Work Order ID 131884

Item ID: D5134-042 Accept ***N900040100*** Setup Start ***NS1***
 Revision ID: Stop ***NS2***
 Item Name: Damper Support Assembly, RH
 Start Date: 4/20/15 Start Qty: 2.00 ***2*** Cust Item ID:
 Required Date: 4/20/15 Req'd Qty: 2.00 ***2*** Customer:
 Reference:

Draw Nbr	Revision Nbr
D5134	A Rev B

Work Order: <u>131884</u>	DISPOSITION Rework ☐ Scrap ☐ Use-as-is ☒ Suspected Unapproved ☐		AGAINST DEPARTMENT/PROCESS

D5134-2 DAMPER SUPPORT, RH

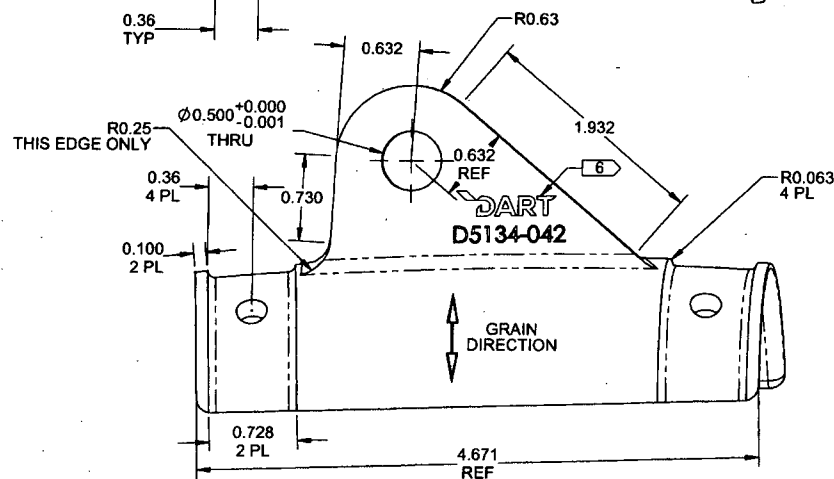
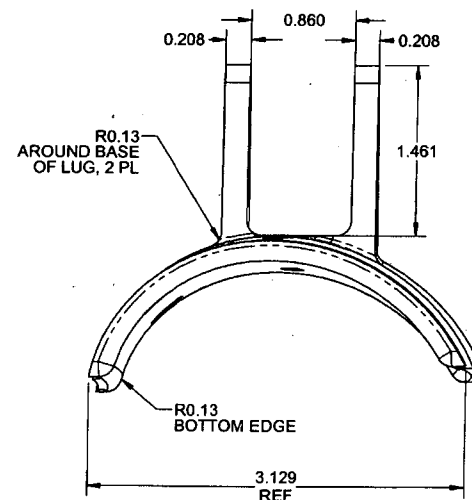
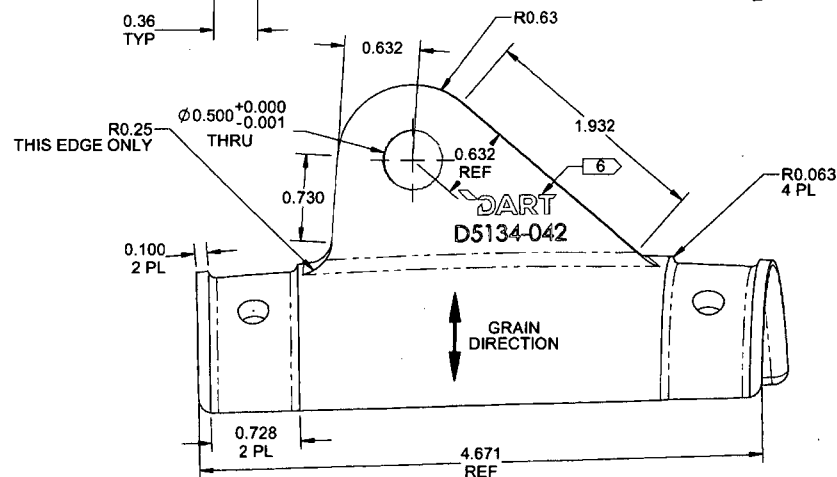
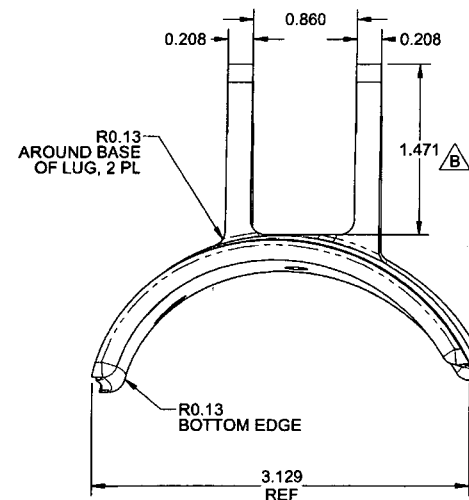
Root Cause	Date	Step	Qty	Description of work order update or non-conformance	Initial Chief Eng	Action Description	Sign & Date	Verification	QC Inspector
Design	15.04.28	110	22	DIM 1.461 IS ACTUALLY 1.471. DRAWING IS WRONG	A.P. 15.04.28	ACCEPTABLE TO USE AS IS. DRAWING WILL BE UPDATED see Rev B drawing.	A.P. 15.04.28	DAS 9 9-89 15-05-29	DAS 9 9-89 15-05-29
Doc/Data									
Equip/Tooling									
Handling/Pre									
Material									
Operator									
Offset/Setup									
Process									
Supplier									
Training									
Transport									
Unapproved

B	7075-T73 MATERIAL WAS 7075-T6, MINOR DIMENSIONAL CHANGES (SHT 3 & 4)	AP	15.04.24
A	NEW ISSUE	AP	14.08.02
REV.	DESCRIPTION	BY	DATE
DESIGN	AP	DART AEROSPACE LTD HAWKESBURY, ONTARIO, CANADA	
DRAWN	AP		
CHECKED	CP	DRAWING NO.	REV. B
MFG. APPR.	JLM	D5134	SHEET 1 OF 4
APPROVED	HS	TITLE	SCALE
DE APPR.	DS	DAMPER SUPPORT ASSY	NTS
DATE	15.04.24	COPYRIGHT © 2014 BY DART AEROSPACE LTD THIS DOCUMENT IS PRIVATE AND CONFIDENTIAL AND IS SUPPLIED ON THE EXPRESS CONDITION THAT IT IS NOT TO BE USED FOR ANY PURPOSE OR COPIED OR COMMUNICATED TO ANY OTHER PERSON WITHOUT WRITTEN PERMISSION FROM DART AEROSPACE LTD.
